F176-02

Proponent: Guy Tomberlin, County of Fairfax; representing ICC Ad Hoc Committee for Hydrogen Gas

SECTION 2209 **HYDROGEN MOTOR-VEHICLE FUEL DISPENSING AND GENERATION STATIONS**

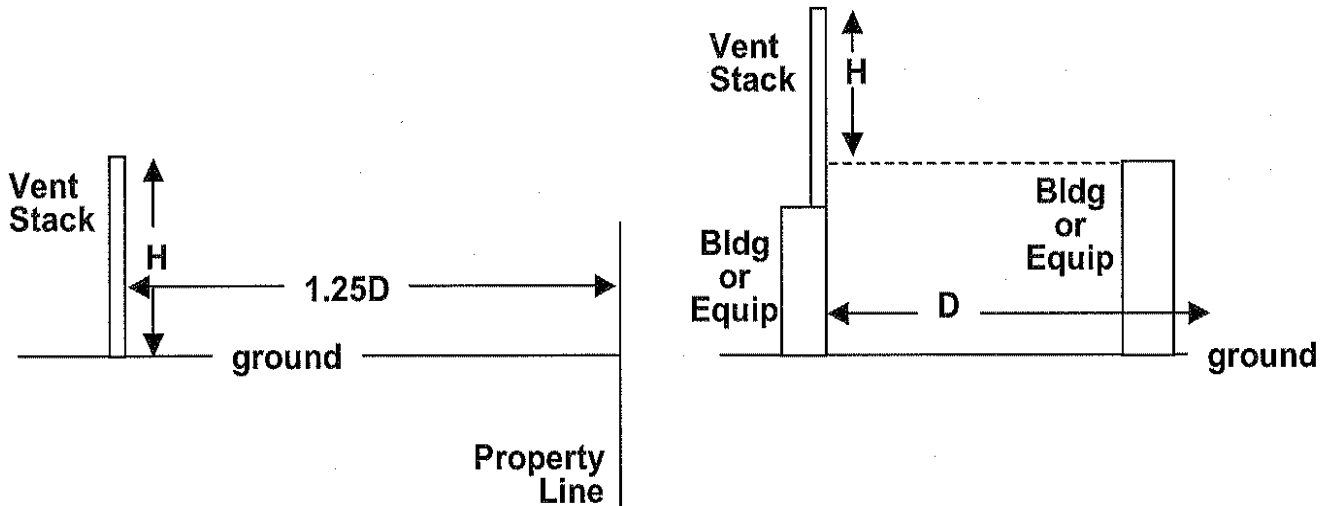
Table 2209.7.4 (Formerly Table 2209.7.1) was revised in several instances as follows:

1. The duplicate headings were reduced to one heading.
2. The legend for 'H' and 'D' was relocated to after the table.
3. The entries on the Table have been simplified. In the majority of the cases it made little difference what size vent was installed, or it was only a matter of several feet difference. Therefore, the distances have been combined to make for easier application of the table.
4. Footnotes and d were revised to refer to lot line rather than property line as lot line is that used within the ICC system.
5. Footnote c has been deleted since it is explanatory information and not regulatory requirements.

a. Minimum distance to property lot line is 1.25D.

b. Designs seeking to achieve greater heights with commensurate reductions in separation distances shall be designed in accordance with accepted engineering practice.
